Desalinated Water Delivery System:
Application for modification of the
Project Approval, Botany Bay Sector
relating to Dredged Material Storage in the Borrow Pit

Water Delivery Alliance
Sydney's Desalination Project

Document number: **WDA-E-REP-043**

Figure 2.1: Project as modified and proposed change – relevant aspects only

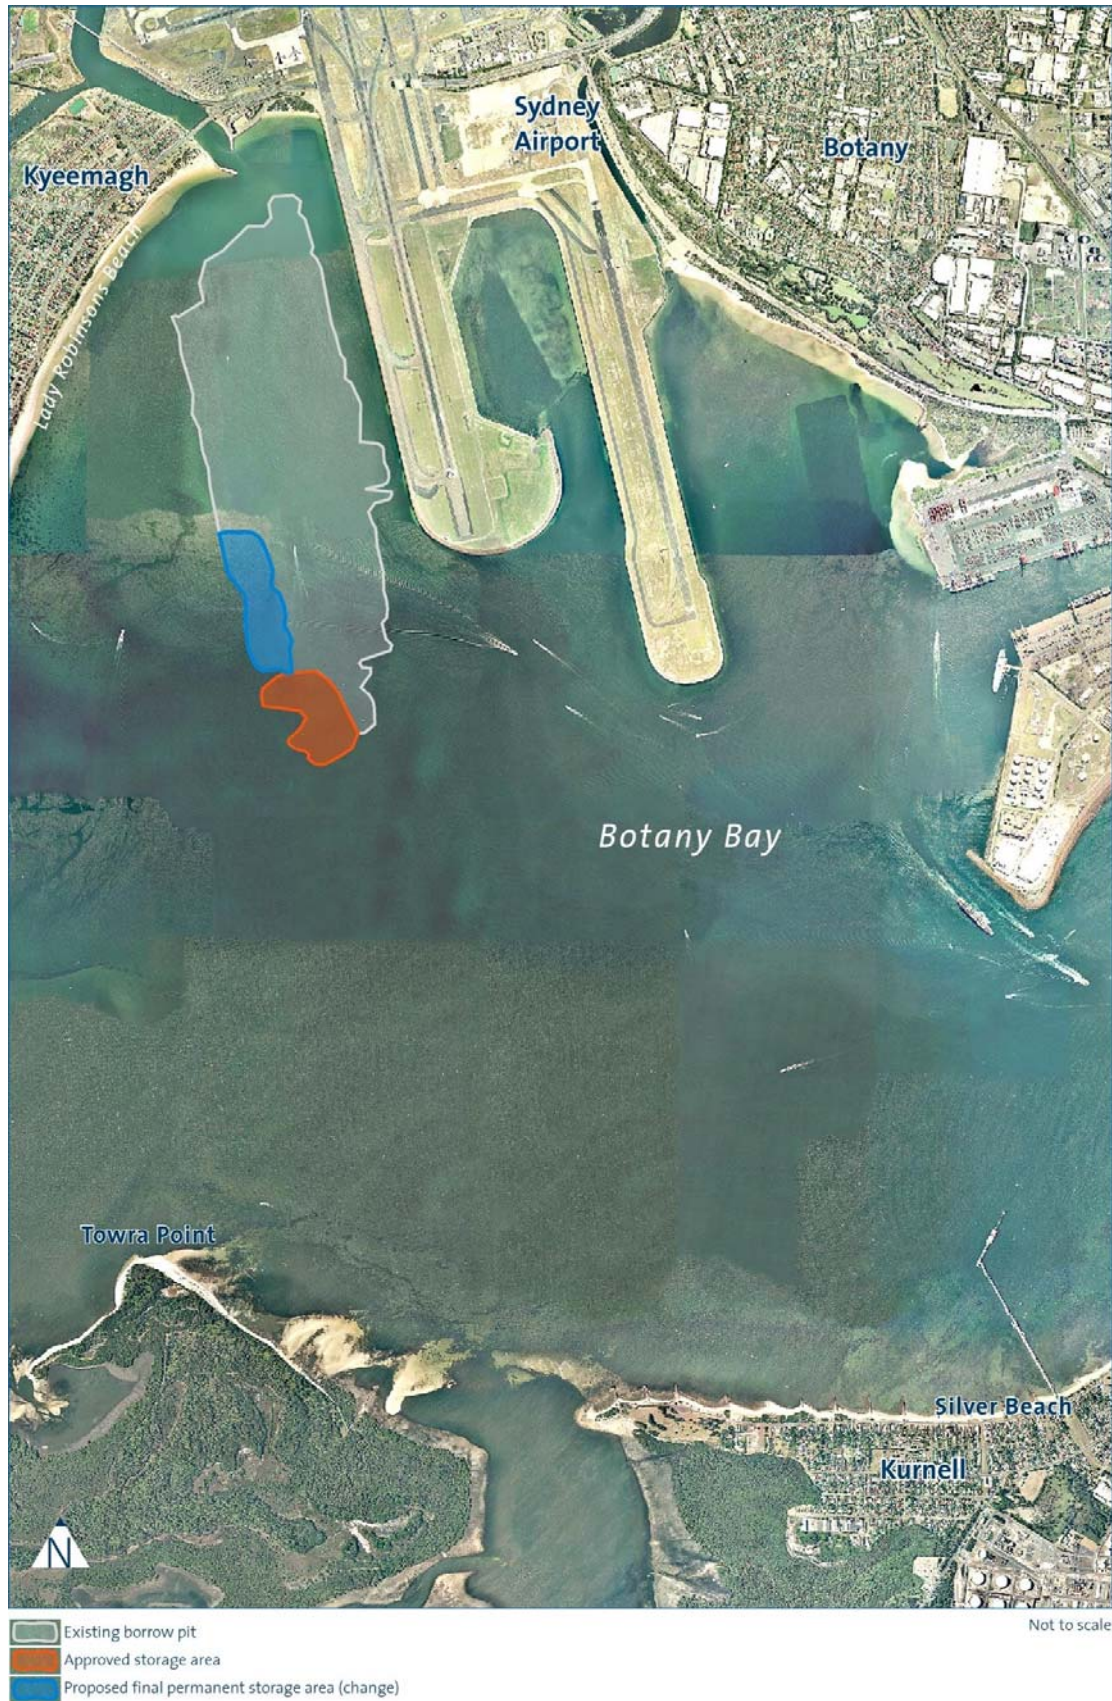
The Modification (15 July 2008) assessed that only temporary storage of approximately 35,000m³ clean sands would be required in the southern portion of the borrow pit. The Modification (15 July 2008) also identified an indicative area for dredged material storage. This area has since changed to a more suitable location (Figure 2.1) in terms of limiting potential impacts to the coastal processes along Lady Robinson's Beach.

WDA now propose to permanently store up to 150,000 m³ of clean sands within the existing borrow pit.

Following discussions with CLT, and in order to minimise the impact on coastal processes of the longterm storage of the actual placed material, it is proposed for the material to be reworked into a thinner layer (below -6.5mCD) by expanding the existing storage eastward, thereby extending the footprint from 100m x 680m to 200m x 680m.

To minimise impacts to coastal processes the dredged spoil will be reworked as a smooth storage below -6.5mCD along the north-south batter as proposed. The north and south batters of this low mound will be profiled as flat as possible (flatter than 1V:10H) to minimise end-effects.
